# NRC Evaluation of the DOE Updated Performance Assessment for Salt Waste Disposal at the Savannah River Site

Details from the NRC Staff Technical Evaluation Report

May 7, 2012

# DOE Base Case and PA Sensitivity Analyses

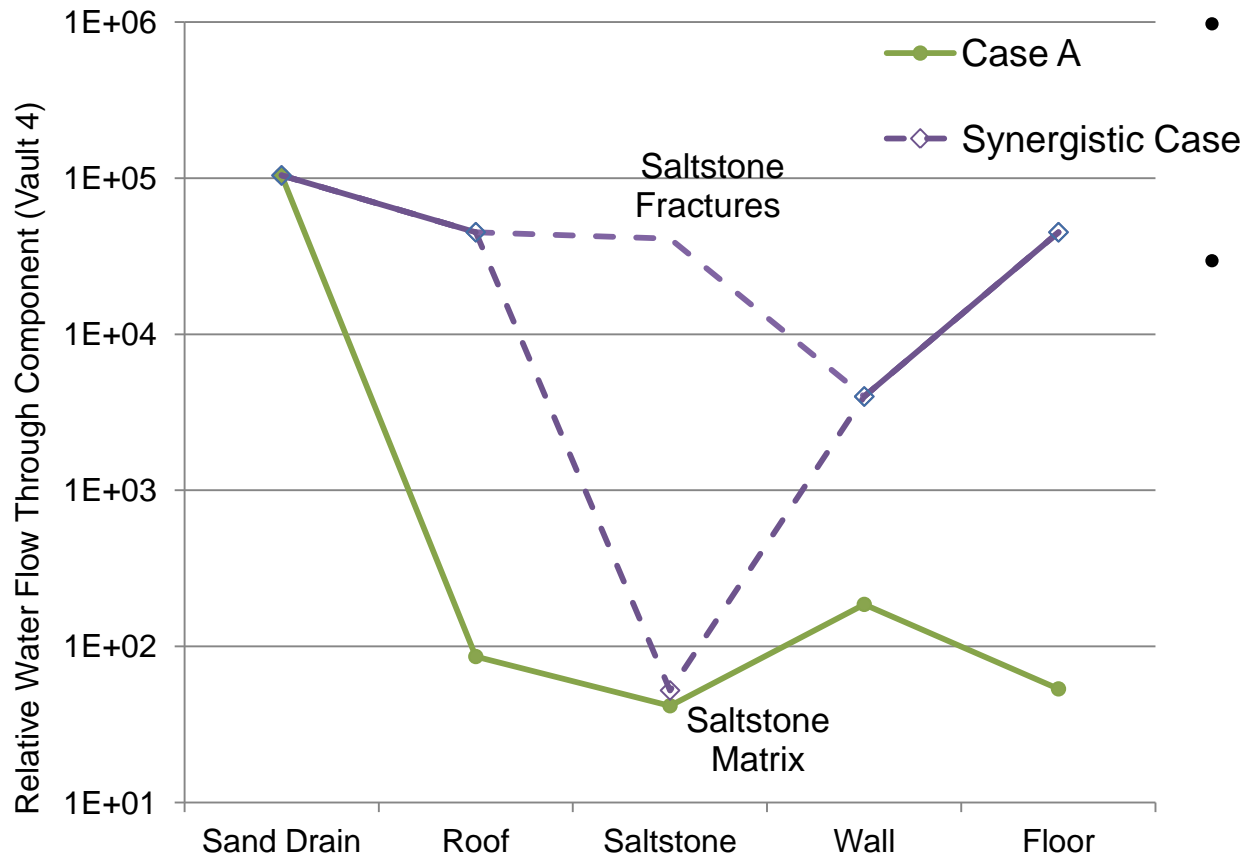
- DOE base case and sensitivity analyses rely on optimistic assumptions about water flow
- Synergistic Case
  - Evaluates degradation of multiple barriers
  - However - routes most water through inventory-free walls (FDCs)
- Importance of intermediate results

# DOE Intermediate Results: Synergistic Case

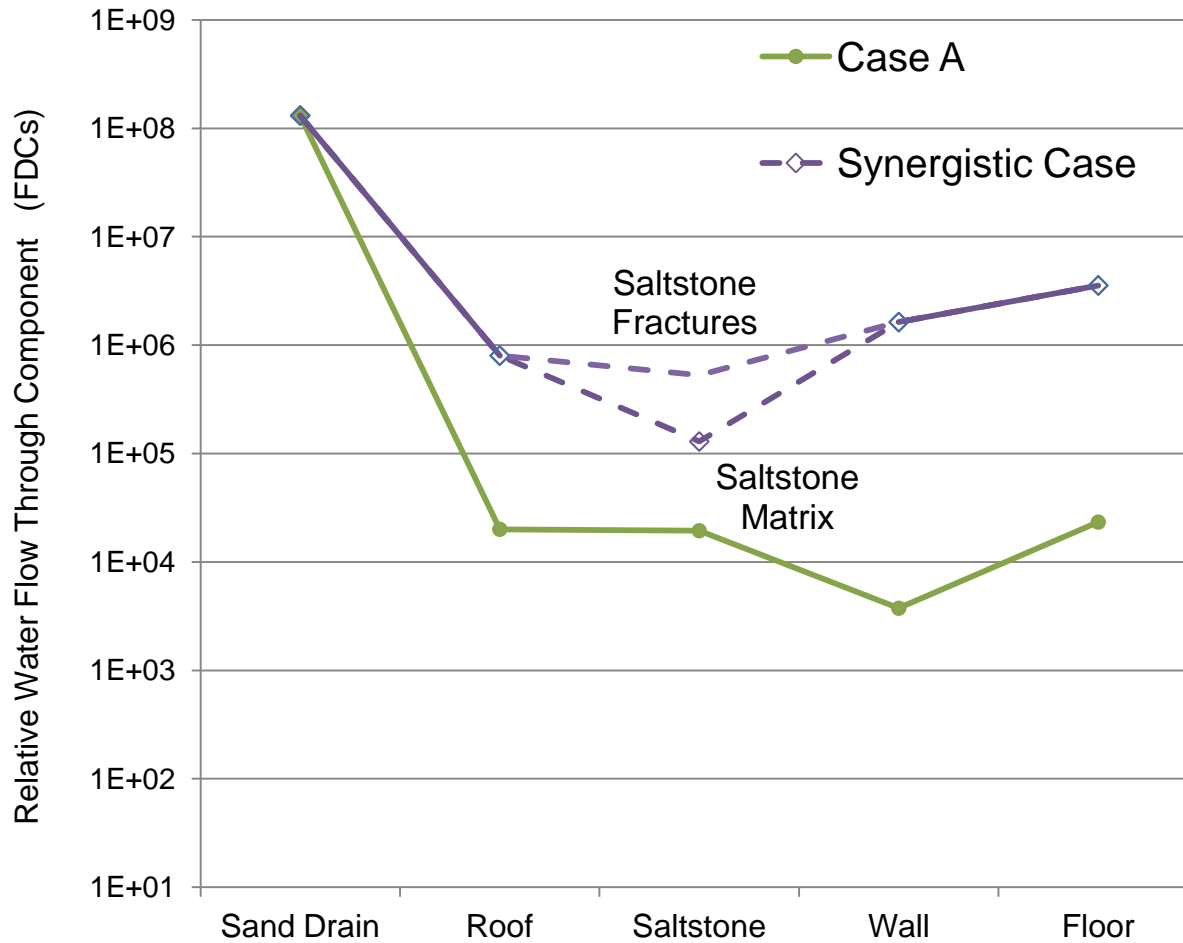
- An order of magnitude more water flows through the disposal unit walls than the saltstone matrix
- Unrealistic given material properties and geometry
- Lowers predicted dose

# Case K: DOE Intermediate Results

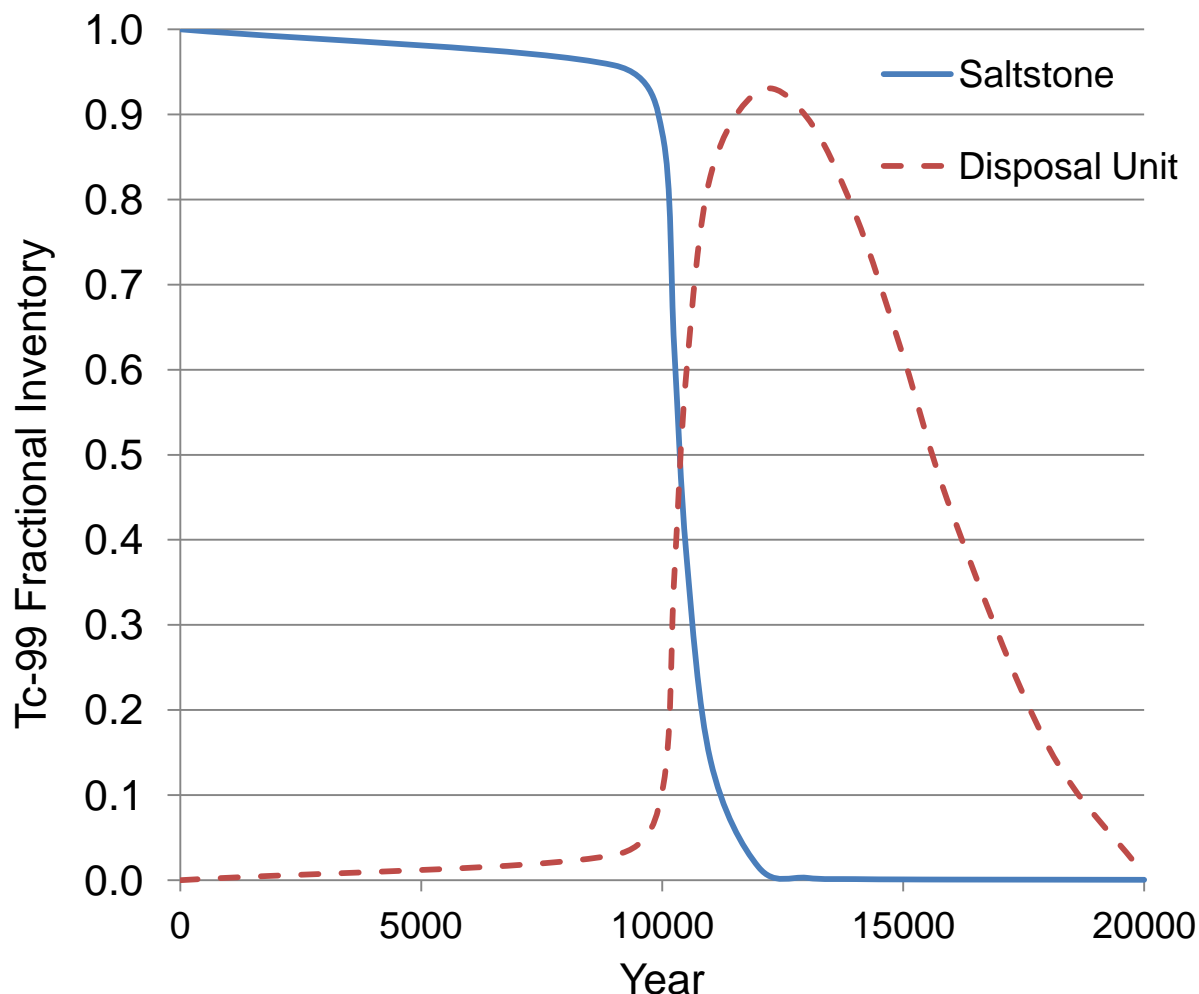
- Tc leaving saltstone nearly all retained in disposal unit concrete
- Reflects a 13X greater Tc concentration in disposal unit floor and walls than in original saltstone
- Unrealistic given material properties
- Significantly lowers predicted dose
